COMMUNITY DEVELOPMENT DEPARTMENT REPORT

SUBJECT: H-2025-0036
Fairbourne Subdivision No. 4

LOCATION: Generally located at the northwest corner of W. Chinden Blvd. & N. Black Cat Rd. at 4837 W. Waverton Dr., in the SE 1/4 of Section 21, T.4N., R.1W.

Combined preliminary and final plat consisting of one (1) buildable lot on 5.2 acres of land in the C-C zoning district.

C. Preliminary Plat (date: 6/12/2025)

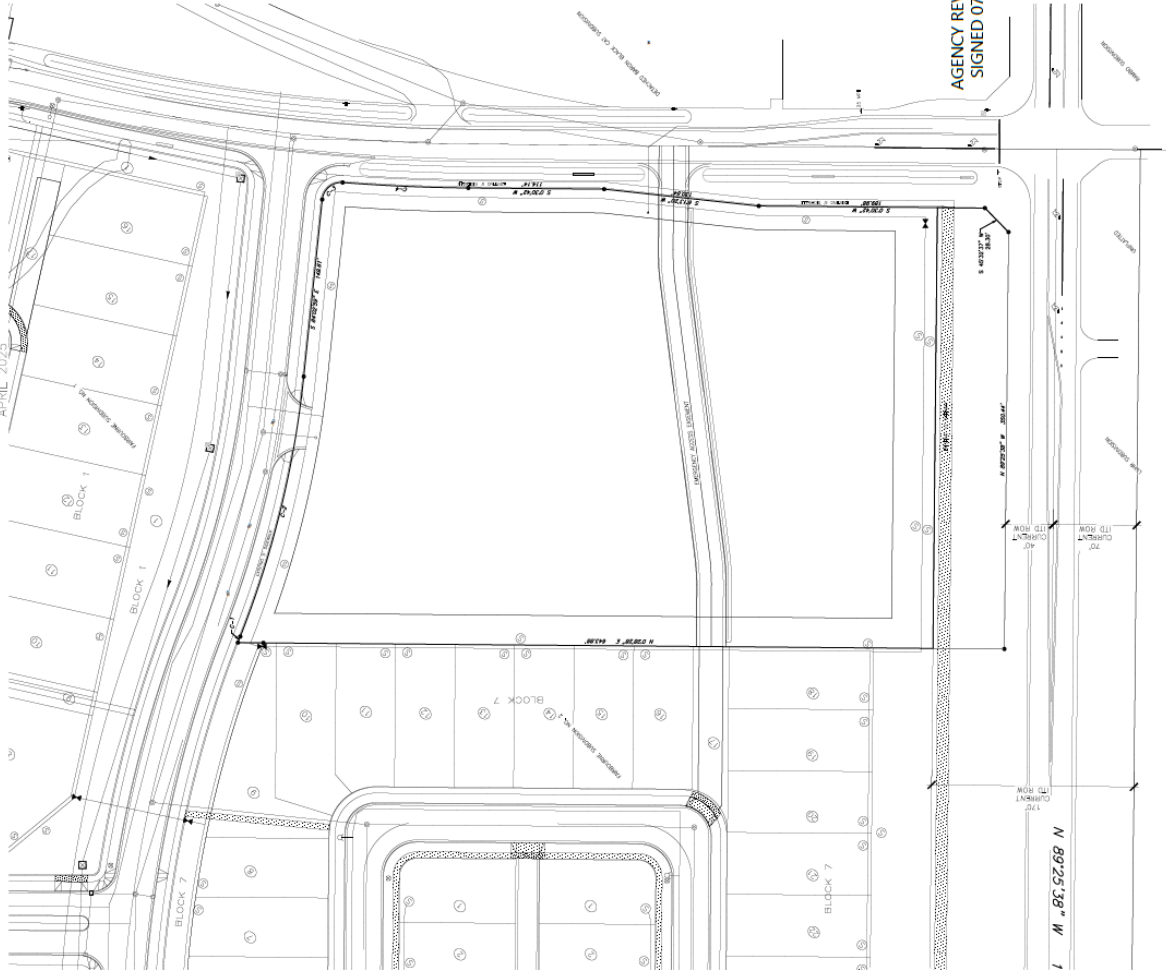
1. Future development shall comply with the provisions in the existing development agreement for Fairbourne Subdivision (H-2018-0052) recorded as Inst. #2018-098361.
2. The final plat shall be revised as follows:
 - i. If ACHD allows the proposed access via N. Black Cat Rd., modify note #6 to *not* prohibit access.
 - ii. Note #10: Include the recorded instrument number of the development agreement (i.e. #2018-0098361.
 - iii. Note #11: Include the recorded instrument number of the ACHD license agreement for landscaping.

The revised plat shall be submitted with the final plat application for City Engineer signature.
3. The landscape plan shall be revised as follows:
 - i. Depict landscaping within the street buffers along W. Chinden Blvd., W. Waverton Dr., and N. Black Cat Rd. per the standards in UDC 11-3B-7C. Additional landscape design features are required along entryway corridors (i.e. Chinden Blvd.) per UDC 11-3B-7C.3f. *The existing landscaping was installed with the adjacent subdivision improvements and was never reviewed for consistency with UDC standards or approved prior to installation. The existing landscaping will need to be supplemented with additional landscaping to comply with current UDC standards.*
